United States Patent and Trademark Office

APPLICATION NO.	FILING DATE	FIRST NAMED INVENTOR	ATTORNEY DOCKET NO.	CONFIRMATION NO.	
10/656,187 09/08/2003		Masami Niimi	117022	8409	
,	25944 7590 10/29/2004		EXAMINER		
	RRIDGE, PLC	GONZALEZ, JULIO C			
P.O. BOX 199	28	ART UNIT PAPER NUMBER			
ALEXANDRIA, VA 22320			2834	TALERNOMBER

Applicati	on No.	Applicant(s)				
			87	NIIMI, MASAMI				
Office Action Summary		Examine	r	Art Unit				
		Julio C. G	ionzalez	2834				
The MAILING DATE of this communication appears on the cover sheet with the correspondence address Period for Reply								
A SHORTENED STATUTORY PERIOD FOR REPLY IS SET TO EXPIRE 3 MONTH(S) FROM THE MAILING DATE OF THIS COMMUNICATION. - Extensions of time may be available under the provisions of 37 CFR 1.136(a). In no event, however, may a reply be timely filed after SIX (6) MONTHS from the mailing date of this communication. - If the period for reply specified above is less than thirty (30) days, a reply within the statutory minimum of thirty (30) days will be considered timely. - If NO period for reply is specified above, the maximum statutory period will apply and will expire SIX (6) MONTHS from the mailing date of this c

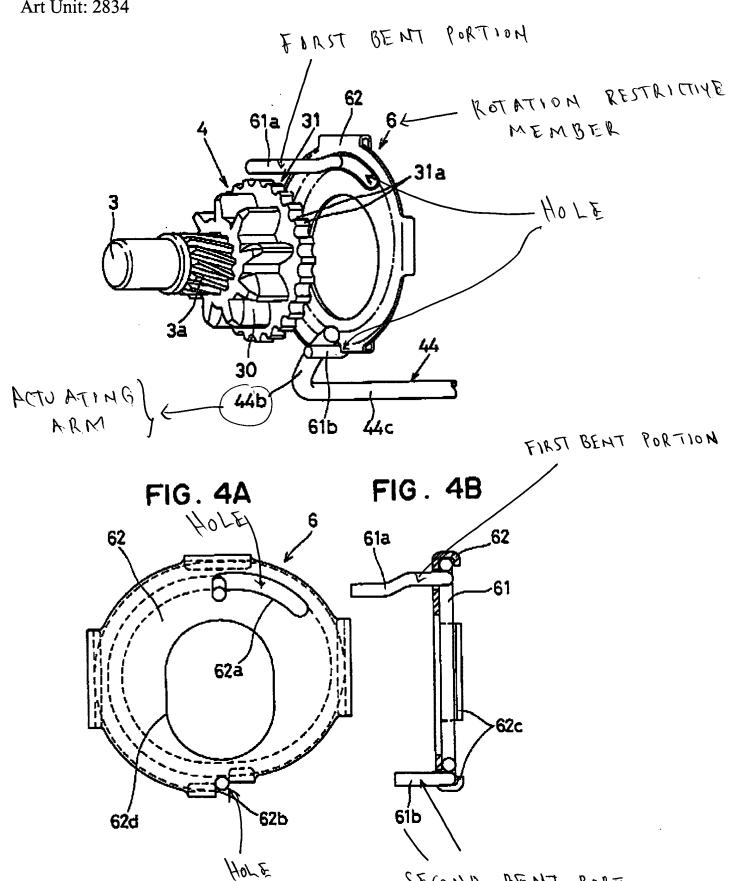
Takagi et al discloses a starter having a motor 2, an output shaft 3, an electromagnetic switch 5, a pinion shift member 4 engaged with the output shaft 3 via helical spline coupling 3a (see figure 2 & column 4, lines 50-53) so as to shift in the axial direction on the output shaft 3 (column 7, lines 18-21), a pinion gear 30 engaging a ring gear 29 of an engine (column 4, lines 41-44) when the pinion shift member 4 shifts in a direction departing from the motor (column 7, lines 22-27).

Also, a rotation restriction member 6 has an engaging portion 61a extending in a direction crossing with a rotational direction of the pinion shift member 4 (see figures 2, 6) for restricting the rotation of the rotation restricting member 6 by engaging with an engaging portion 31a of the pinion shift member 4 and an actuating means 44 for actuating the rotation restricting member 6 by using a magnetic force generated from the electromagnetic switch 5 (see figure 7 & column 6, lines 51-65) and the actuating means 44 has a rod portion 44c rotating in response to the magnetic force of the electromagnetic switch 5 (see figure 1 & column 6, lines 18-32) and an actuating arm 44b (see figures 1 & 2) formed at distal end of the rod portion 44c so as to swing about an axis of the rod portion 44c when rod portion 44c rotates (column 6, lines 18-32) and the rotation restricting member 6 is assembled with the actuating arm 44b (see figure 2).

Moreover, the rotation restricting member 6 has a first bent portion and second bent portion which are parallel to each other (see figures 2, 4A, 4B & column 5, lines 20-22) and have coupling holes through which the rotation restricting member 6 is assembled with the actuating arm 44b and the engaging portion 61a of the rotation restriction member 6 is provided on the first bend portion (see illustration on next page).
